**Technical Review Documentation**  
**Flooding Hazard Reevaluation of**  
**Quad Cities Nuclear Power Station, Units 1 and 2**  
**Prepared by**  
**Oak Ridge National Laboratory**  
**October 31, 2016**

This document supplements the input to the Nuclear Regulatory Commission (NRC) Office of Nuclear Reactor Regulation Staff Assessment of the Flooding Hazard Reevaluation Report for the Quad Cities Nuclear Power Station (Quad Cities), Units 1 and 2. This document provides a summary of ORNL's technical review of the development, application, and effect of flooding hazards on water levels at the Quad Cities site as provided by the licensee in its Flood Hazard Reevaluation Report (FHRR). The review process undertaken by the ORNL staff included a review of the information submitted by the licensee; examination and evaluation for appropriateness and conservatism of the licensee's conceptual models and assumptions; checking of the licensee's information (including input files for computer models) for completeness, internal consistency and consistency with technical sources; and examination of the electronic files that document the licensee's analysis for indications of errors or computat

**Figure A-2 – ORNL evaluation of storm representative dew point conversion factor**

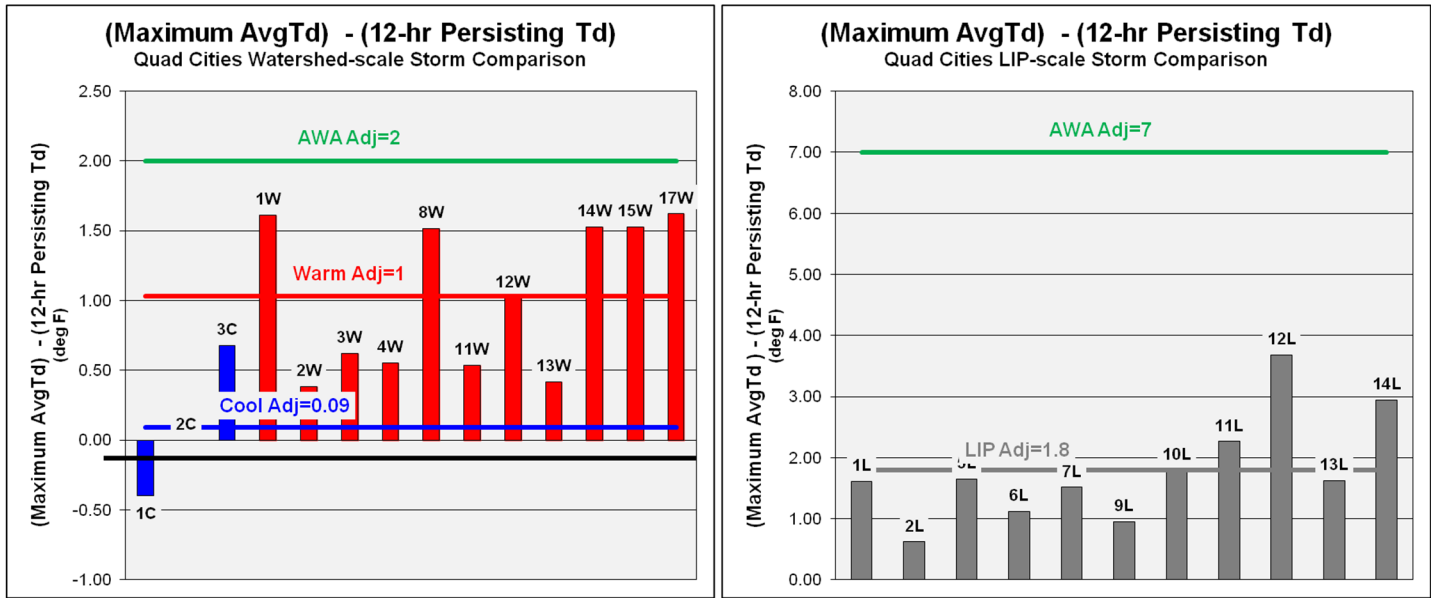
Compared with AWA’s selected observational dew point adjustment factor of 2 degrees F, the computed adjustment factor for cool-season storms ranges from -0.4 degree F to +0.7 degree F, with an average of +0.09 degree F. For warm-season storms, the adjustment range is +0.3 degree F to +1.6 degree F, with an average of +1.0 degree F. These values are significantly lower than the values purposed by AWA and would typically result in sizable increases in PMP for the storms for which this adjustment was needed. For LIP storms, the adjustment ranges from +0.6 to +3.7 degree F, with an average of +1.8 degree F. Compared with the AWA adjustment values for LIP-type storms (7 degree F), these adjustment values are significantly lower and would typically result in sizable increases in PMP for those storms (note: 1 degree F difference is approximately a 4-5% change in PMP).

The staff noted that while the 7 degree difference between maximum 12-h persisting and 6-h average dew point is possible, it is only observed in few individual weather stations and does not seem to be spatially consistent with other neighboring stations. When selecting storm representative dew point, it is preferred to use the spatially averaged hourly dew point data (from multiple stations in the moisture source region, HMR approach) and after this process, the large difference is usually reduced further. Therefore, the largest adjustment factor in this analysis is only 4.0 degree F (the Stanton\_Nebraska 12L LIP storm listed in Table A-1) instead of 7.0 degree F.

For the purpose of sensitivity analysis, ORNL recommended keeping the 2 degree F adjustment factors for all past WS-PMP storms, but lowering the adjustment factor from 7 degree F to 2 degree F for all LIP-PMP storms. For warm season WS-PMP, the difference between AWA and the ORNL sensitivity analysis was only 1 degree F. For cool season WS-PMP, while the difference is larger (2 degree F), there are only 3 storms so it may not be sufficient to draw conclusion. Therefore, the 2 degree F adjustment factor is maintained for WS-PMP. On the contrary, for LIP-PMP, a major distinction is noticeable in comparing the results of staff's sensitivity analysis with the averaged adjustment value used by AWA. Based on the ORNL's independent analysis of 11 LIP-scale storms, a 2 degree F adjustment factor was suggested for LIP-PMP storms<sup>5</sup>.

**Figure A-3 – Example of gauge-based dew point climatology**

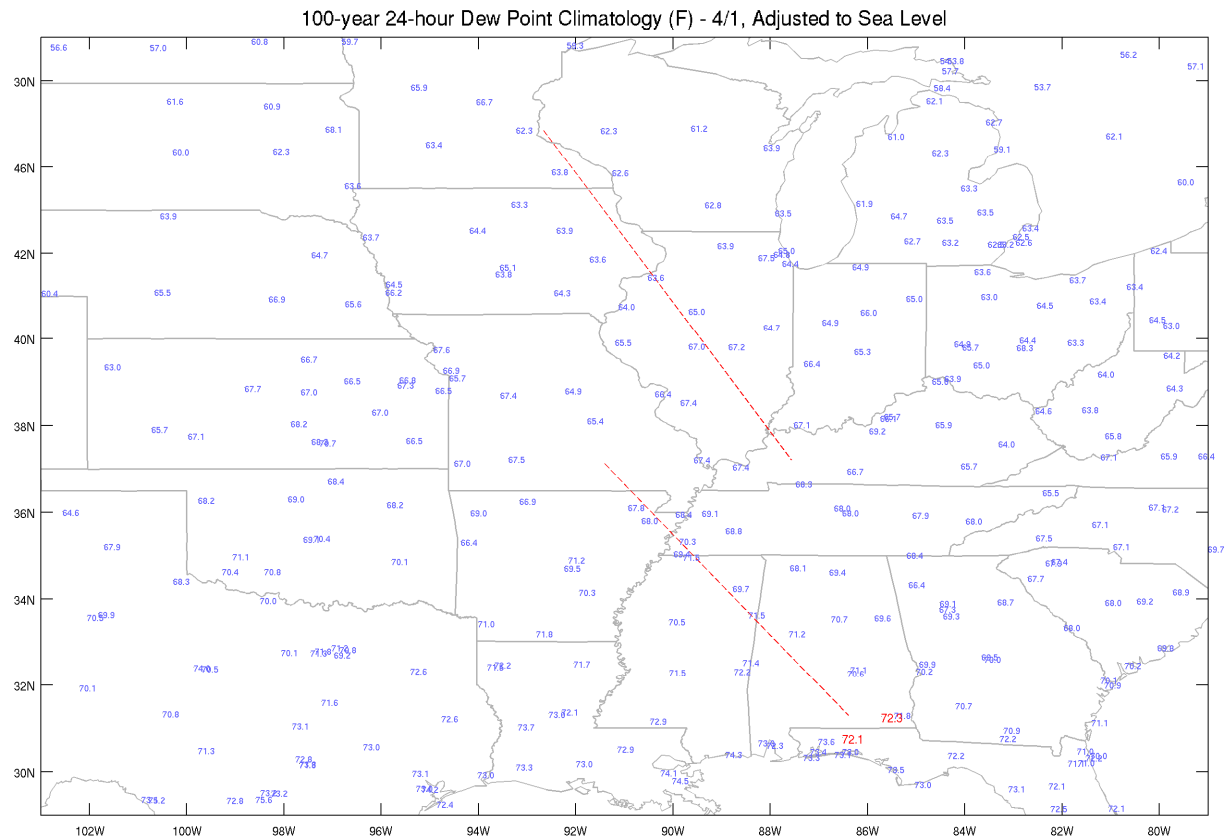
15<sup>th</sup> maps) are illustrated in Figure A-3 as an example. The maps are constructed for all Quad Cities short list storms to help look up the dew point climatology values.

For the purpose of sensitivity analysis, ORNL updated dew point climatology values using the gauge-based results. The selection of dew point climatology value was made directly by considering various stations in the moisture region.

**Figure A-10 – LIP-PMP Dew Point Comparison Using AWA +7 degree F adjustment**

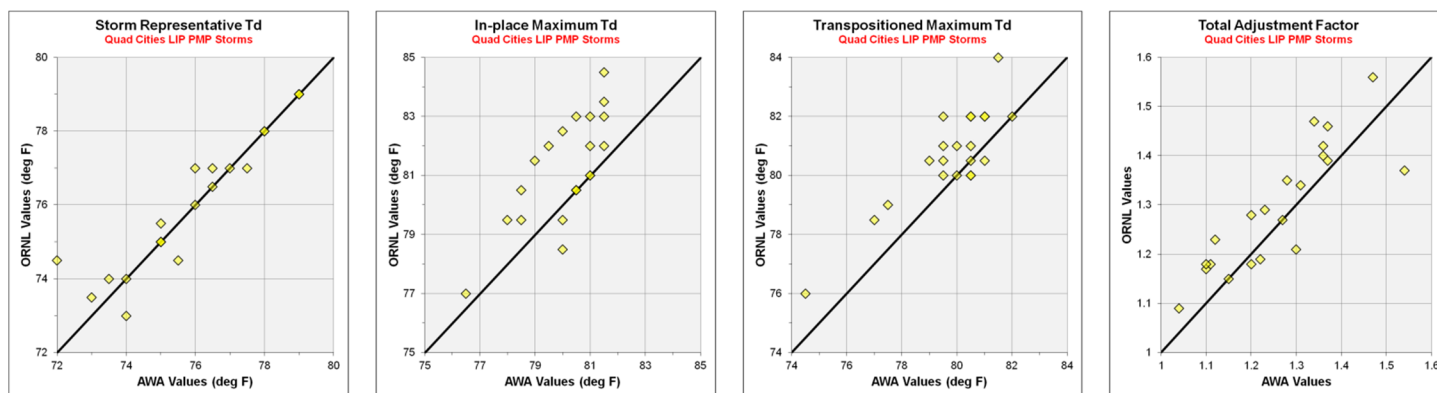
As shown in Figure A-10 and Figure A-11, the total adjustment factor is based on values of storm representative dew Td, in-place maximum Td, and transpositioned maximum Td. The majority of WS-PMP storms show higher total adjustment factors under ORNL's approach compared to AWA's results. Once computed, the total adjustment factor is used to modify observed 1-hr, 1-mi<sup>2</sup> PMP.

**Figure A-13 – Comparison of maximum water-surface elevation (WSE) from various cool-season WS-PMP cases**

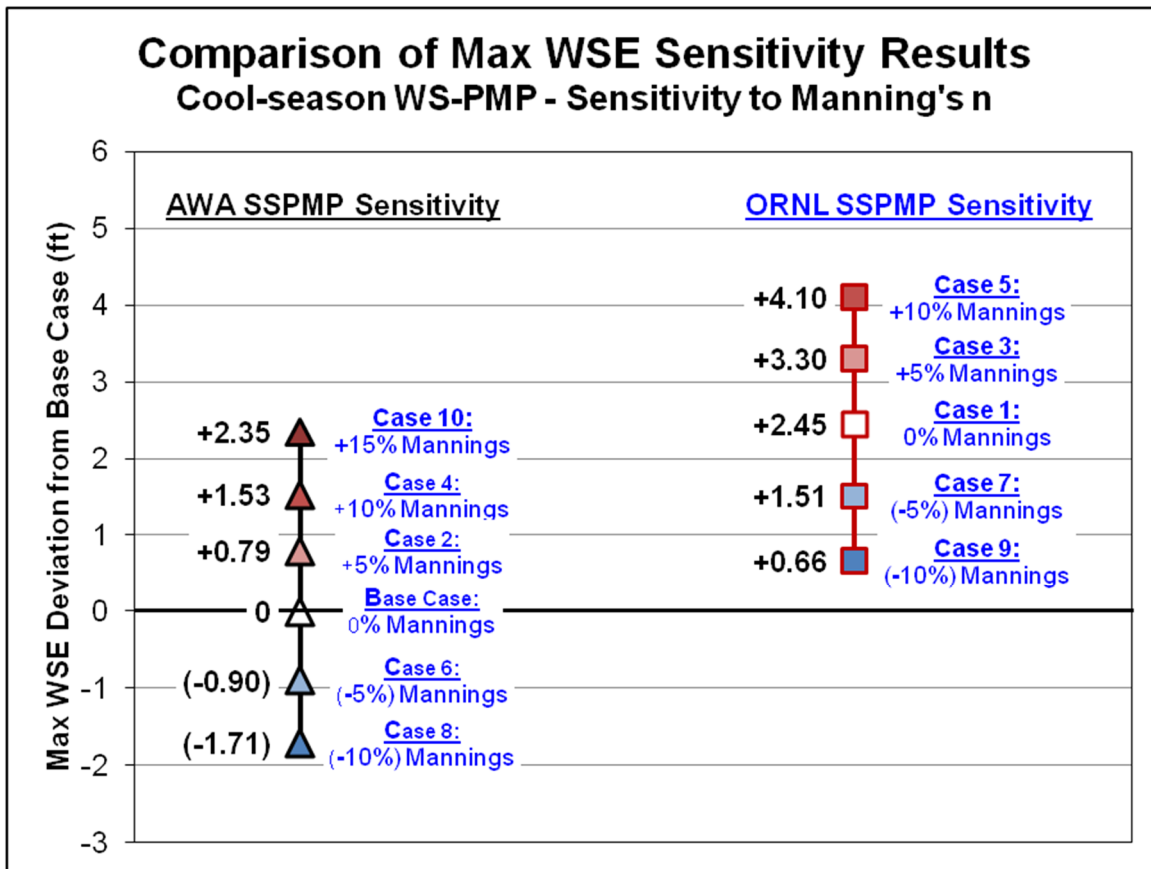
Based on the results for the elevation and flow at the Quad Cities site in Table A-5 and Figure A-13, the 8.7% increase in the ssPMP values result in a roughly 2.5-feet (ft) increase in flood water elevation accompanied by a 12% gain in peak flow of 836,465 ft<sup>3</sup>/s or roughly 92,000 ft<sup>3</sup>/s more flow. This increase in elevation due to the scenario of an 8.7% increase in the ssPMP was roughly equivalent to a 15% increase in the value for Manning's  $n$  using the licensee's ssPMP. A 15% increase of the value Manning's  $n$  for the main channel of the Mississippi was still within acceptable ranges for the type of channel given that the licensee's choice of the main channel value corresponds to the normal value on a range from minimum to maximum.

Figure A-15 – Comparison of maximum water depth from various LIP flooding sensitivity analyses

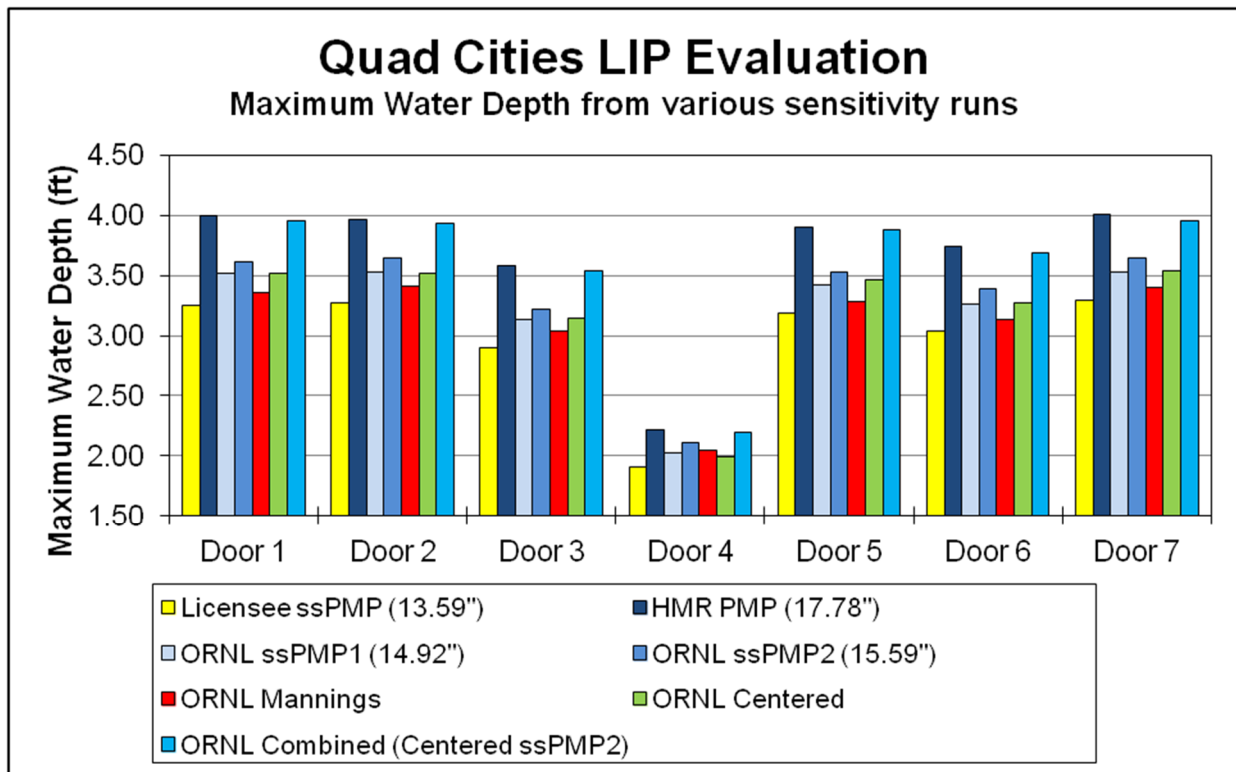
The maximum WSE at 7 doors of interest were compared across each of the sensitivity runs. The results indicated that, as expected, WSE's increase with increasing rainfall input to the model. The HMR rainfall values (LIP Run 2) were the highest of any scenario evaluated and resulted in the highest predicted flooding on site. The ORNL reanalysis results (LIP Runs 3 and 4) were lower than the HMR results, but still notably higher than the licensee's results. In comparison to sensitivity of total rainfall, the sensitivity conducted on varying Manning's  $n$  values (LIP Run 5) was lower, while sensitivity to rainfall distribution (LIP Run 6) was slightly lower than ssPMP2. These results clearly demonstrate that total rainfall and rainfall distribution are the key parameters influencing maximum WSE. For Manning's  $n$  values, the licensee had previously stated that when using the upper and lower range of Manning's  $n$  values resulted in maximum WSE variation of  $\pm 0.1$  ft, which is outweighed by variation in maximum WSE due to total rainfall and rainfall distribution.

The results are graphically represented in Figure A-15 below and are summarized in Table A-6.
